| Model | | ARDF for M210 ,NC11, and N230 (Ricoh DF57, Savin 9180, NRG RF 3020, infotec ARDF IV/II) | | | | | | Volt/Hz | Date of Modification | Serial Number | |
| Modified Article | | Decal - Mode Confirmation | | | | | | | | | |
| Reason for Modification | | To ensure normal mode setting | | | | | | | | | |

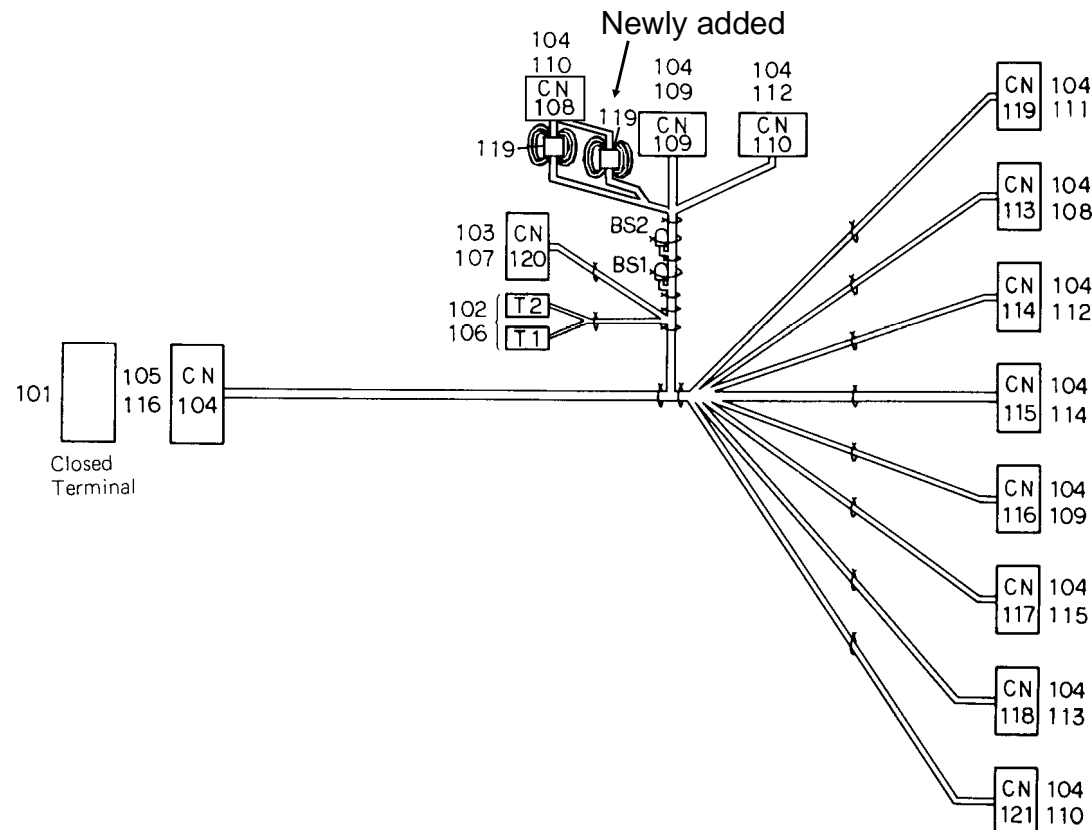
1. The DF Main Board has been modified to reduce the level of electrical noise.

2. A Ferrite Core has been added to the Main Harness to absorb electrical noise.
